Economic Commission for Europe**Inland Transport Committee****World Forum for Harmonization of Vehicle Regulations****Working Party on Pollution and Energy****Eighty-sixth session**

Light vehicles: UN Regulations Nos. 68 (Measurement of the maximum speed, including electric vehicles), 83 (Emissions of M₁ and N₁ vehicles), 101 (CO₂ emissions/fuel consumption), 103 (Replacement pollution control devices) and 154 (Worldwide harmonized Light vehicles Test Procedures (WLTP))**Proposal for a new supplement to the original series of UN Regulation No. 154 (Worldwide harmonized Light vehicles Test Procedures (WLTP))****Submitted by the International Organization of Motor Vehicle Manufacturers* ****

The text reproduced below was prepared by the experts from the International Organization of Motor Vehicle Manufacturers (OICA). It proposes to incorporate corrections and clarifications which were identified during the development of the 02 series of amendments. The modifications to the current text of the Resolution are marked in bold for new or strikethrough for deleted characters.

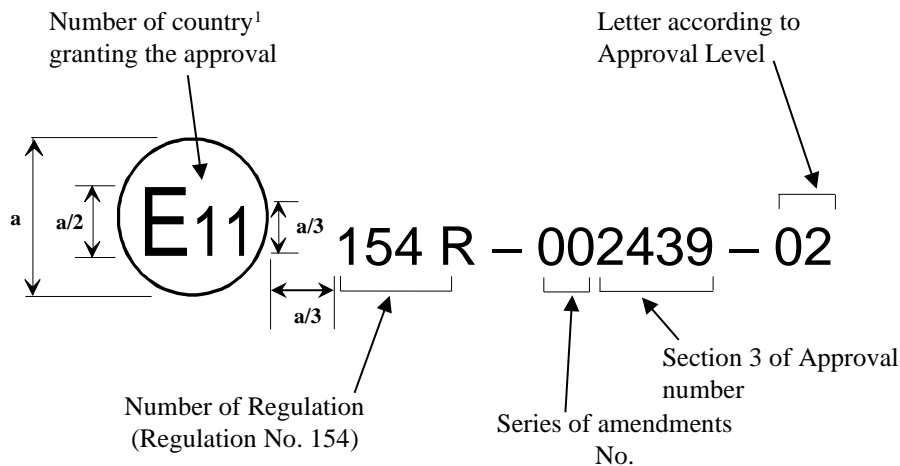
Annex A3, amend the first graphic with a space between 154 and R to read:

a = 8 mm (minimum) "

Figure A5/14

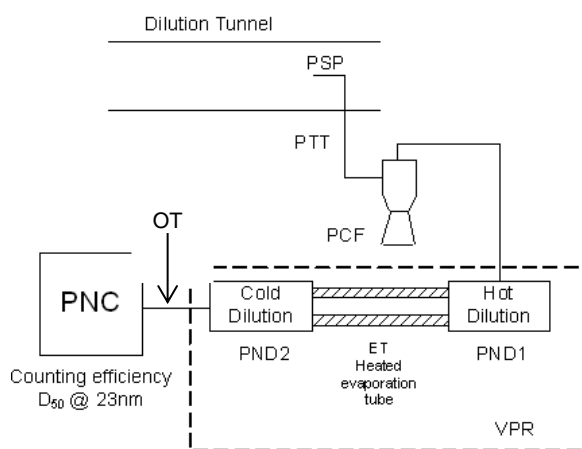
The following paragraph contains the recommended practice for measurement of PN. However, systems meeting the performance specifications in paragraphs 4.3.1.2. and 4.3.1.3. of this annex are acceptable. **See Figure A5/14.**

The evaporation tube, ET, may be catalytically active with a wall temperature of 350 °C (± 10 °C). "
